**TOWN OF HERNDON, VIRGINIA
ARCHITECTURAL REVIEW BOARD
WORK SESSION AGENDA
JULY 1, 2020
HERNDON COUNCIL CHAMBERS BUILDING
765 LYNN STREET
7:30 P.M.**

5. **Parkview Mixed Use Development – Building and Landscape Architecture Review(2nd Submission)**: Follow-up Board discussion item regarding the revised design (2nd ARB submission) of a future mixed use, transit-oriented development in the Herndon Transit-Oriented Core (HTOC), which is the subject of a formal rezoning application, DP # 19-01 currently under review.

Subject: Discussion Item – Development Plan for Parkview HTOC Development Plan

Proposed sign

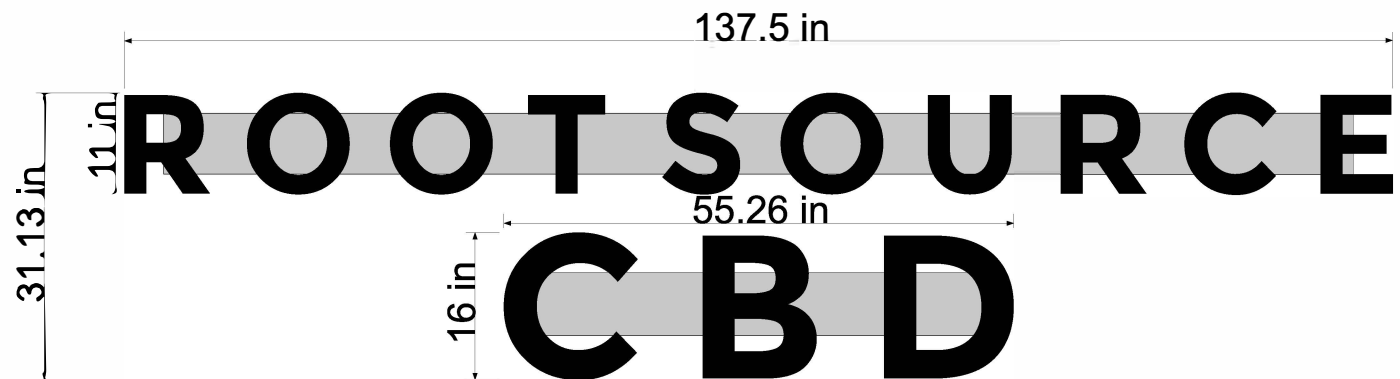
• Channel letter depth and trim cap dimensions on the sign design drawings; • Channel letter facing material and covering specifications • Channel letter section drawing with dimensions and showing internal illumination detail(s) 2. The proposed sign shall be installed in substantial conformance with the original application design and construction details as submitted on or about June 3, 2020.
--	--

(This View was Not in the Original Submission) SOUTH ELEVATION – BUILDING A & B

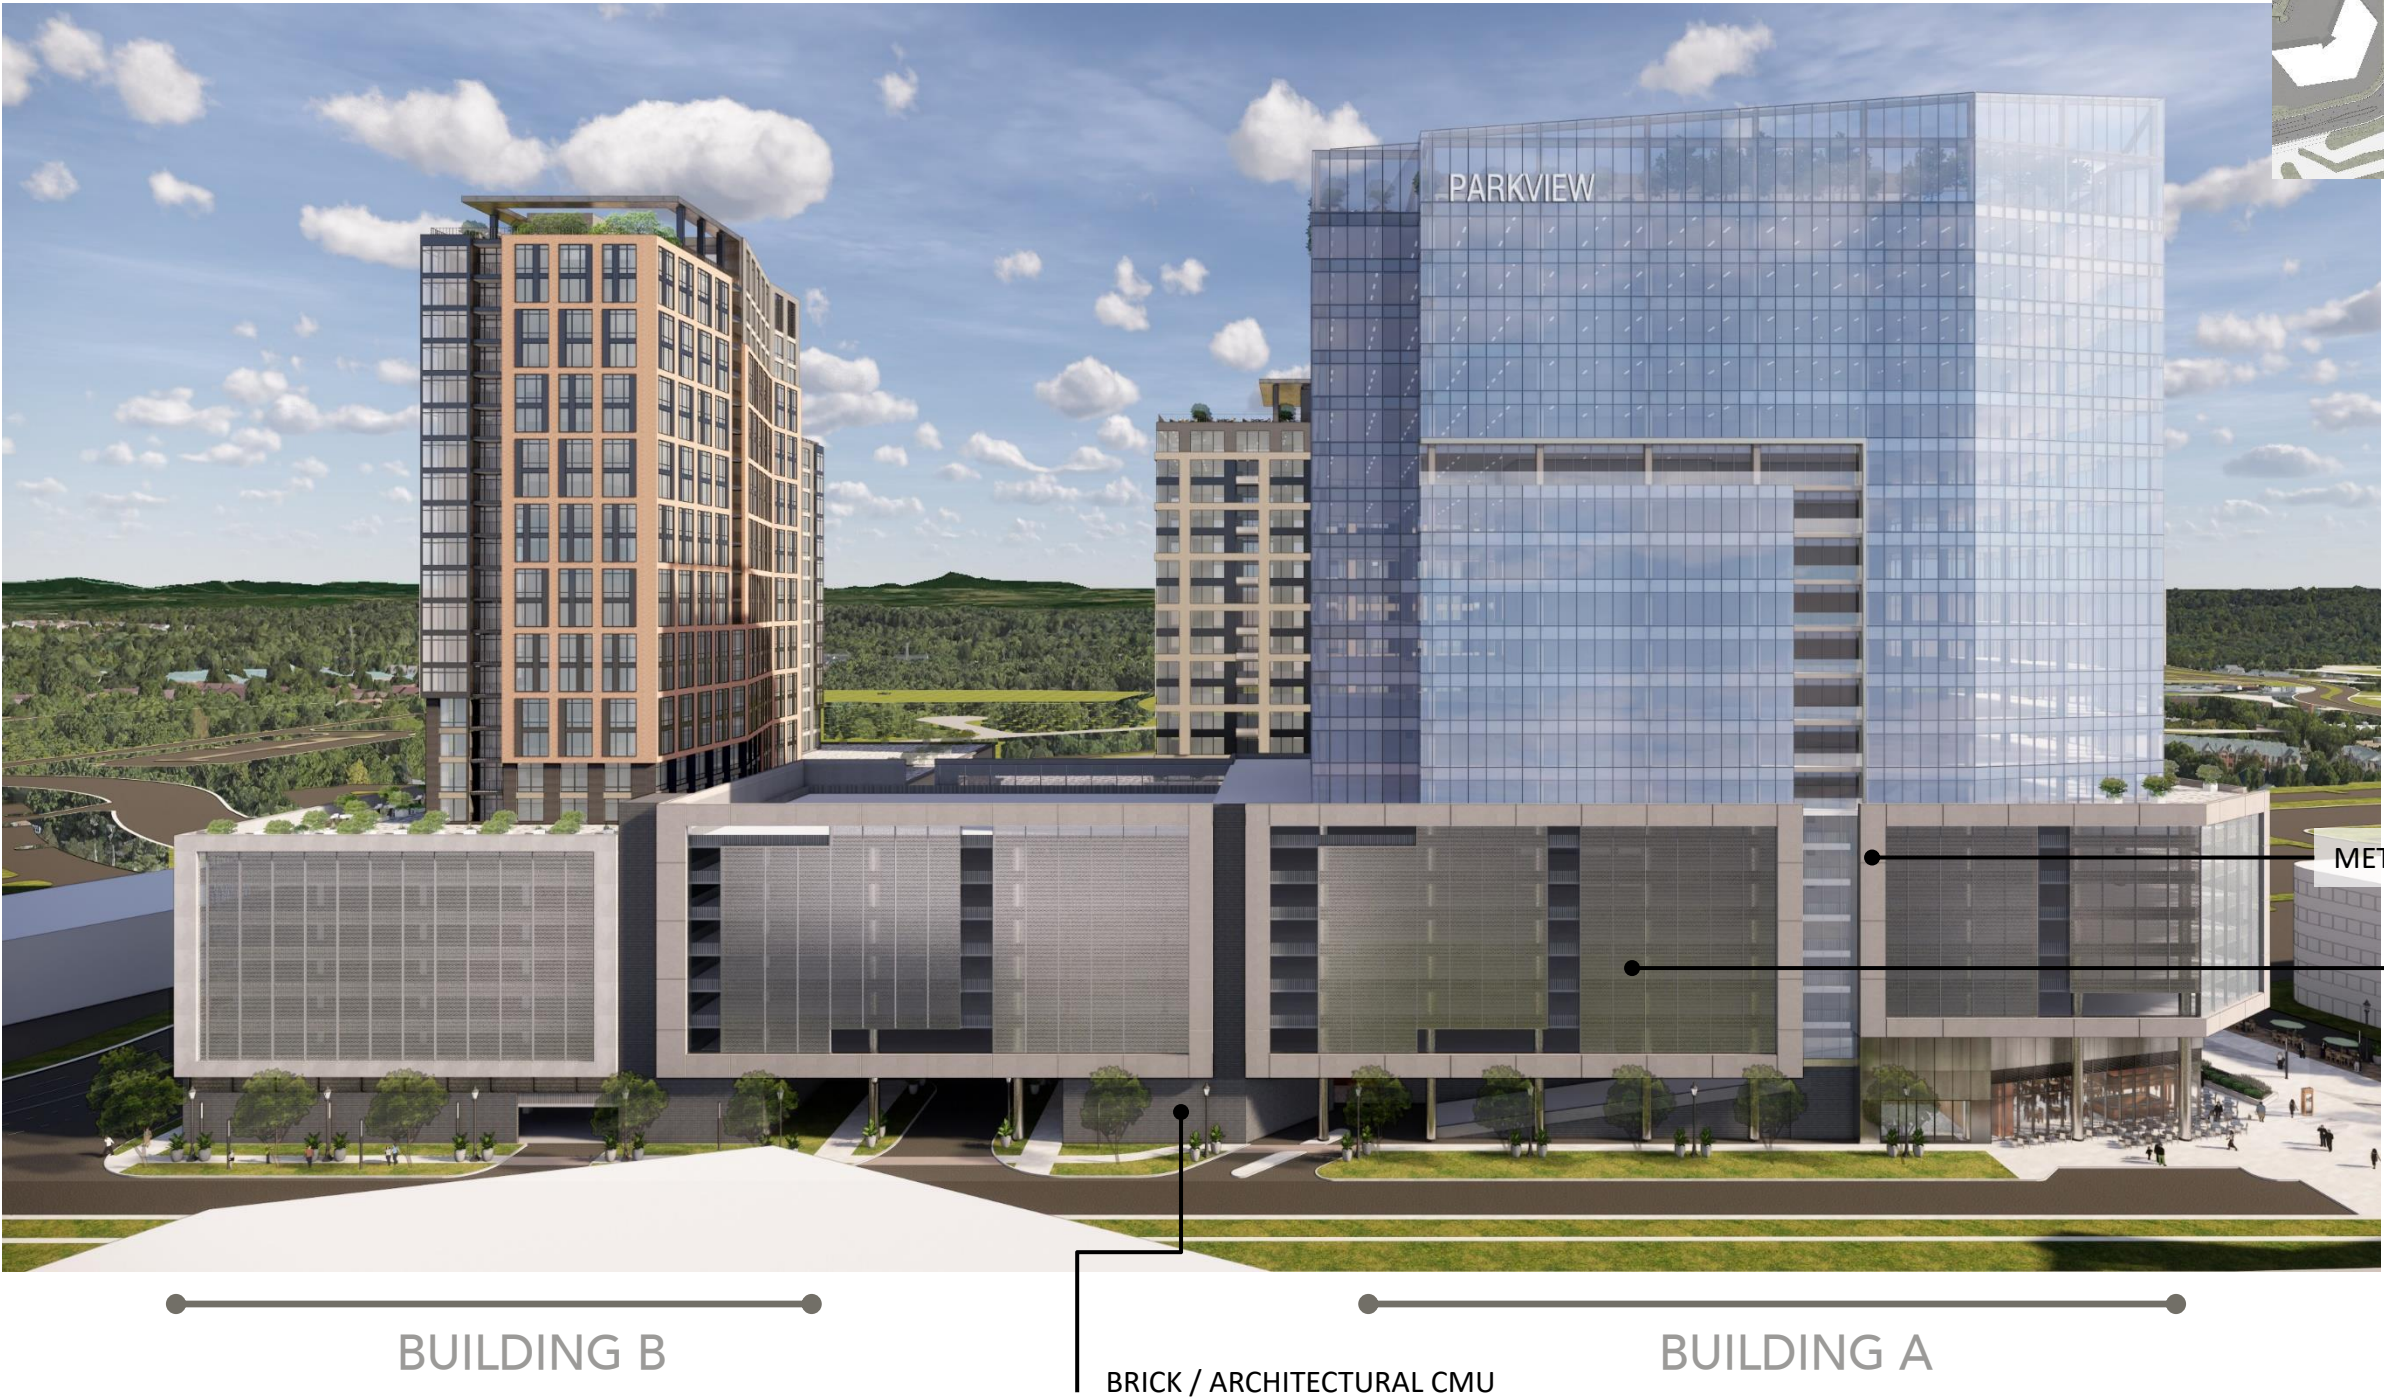
- Elevation drawings with exterior materials labeled. The provided drawings are not drawn in elevation are inconsistent with material labels.
 - Information conveying the appearance of the proposed materials. The drawings, given their scale, cannot effectively portray the actual material color, texture, pattern, and scale. A sheet in the GDP with close up images of the materials to be used would be a useful supplement to fill this gap in information. This is covered more in Comment #5 below.

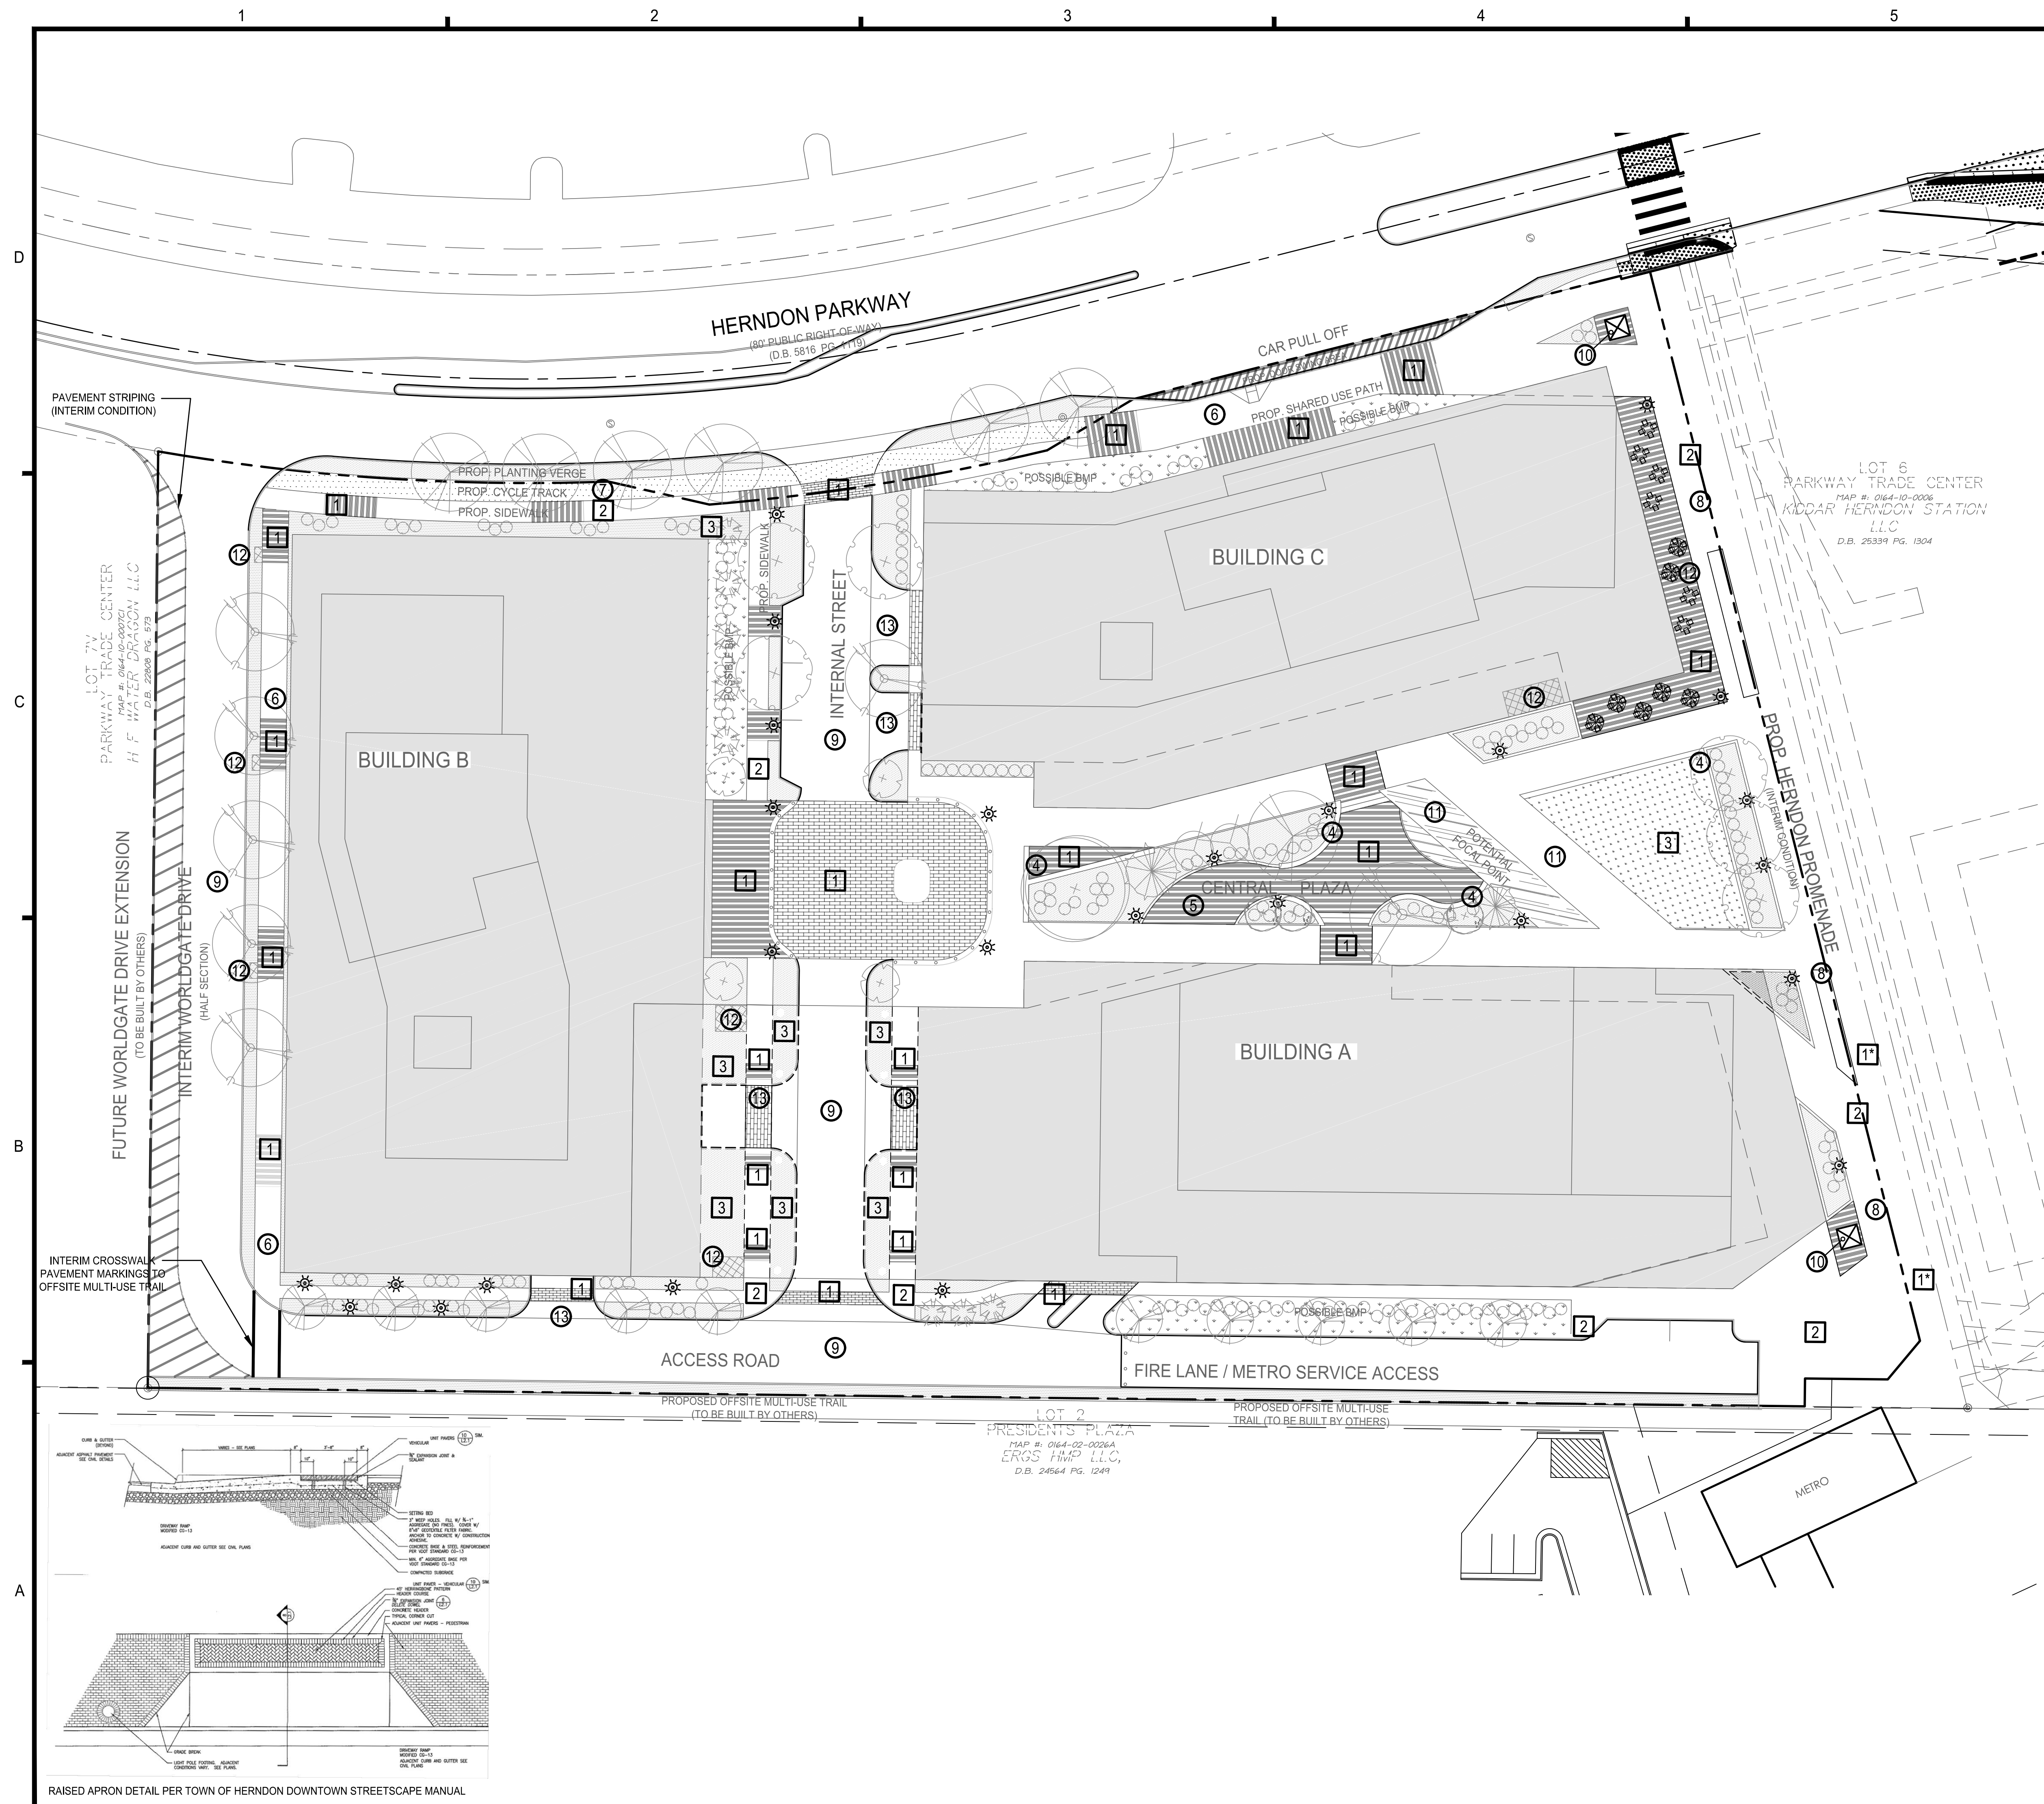
- 6) **Open Space Design:** As noted in Comment #1 above, there remains a disconnect between the open space design as shown in the architectural renderings and the open space design actually proposed for this development. This is most prevalent at the Promenade. There are also information issues with the illustrative landscape design sheet included in the ARB exhibit (Page 20) which is not legible for the information it is attempting to convey, nor does it show the Promenade design as intended. This disconnect is largely due to the difference and between what is being proposed for this project and what may ultimately be designed for the Promenade which is located on three different properties. To help clarify, staff has provided the Landscape and Hardscape plan sheets from the GDP that show what is being proposed.

Staff evaluation of the Promenade is based solely off these two GDP sheets and not the drawings and plans in the ARB exhibit. There are several items that concern staff regarding the Promenade design:

- The majority of the surface material is brushed concrete. The guidelines call for a minimum use of 60% pavers for all hardscaped areas. The use of pavers that provide interesting patterns, colors, and textures are vital to the design quality and experience of the Promenade.

- There is minimal landscaping. The guidelines call for a minimum of 30% landscaped areas. Note that the 6 ornamental trees shown on the illustrative landscape plan are not proposed. The use of landscaping is important to help balance and soften the hard edges and hardscape finishes of the Promenade. Trees also provide shade and can frame outdoor spaces that may otherwise be overwhelmed by the proximity and scale of the abutting buildings.

- There are minimal breaks in the floor plane and lack of focal points, built in areas for respite, and opportunities for pedestrian engagement with the landscape. Combined these types of components begin to contribute towards the vision sought for the Promenade as the principal open space amenity of the HTOC.
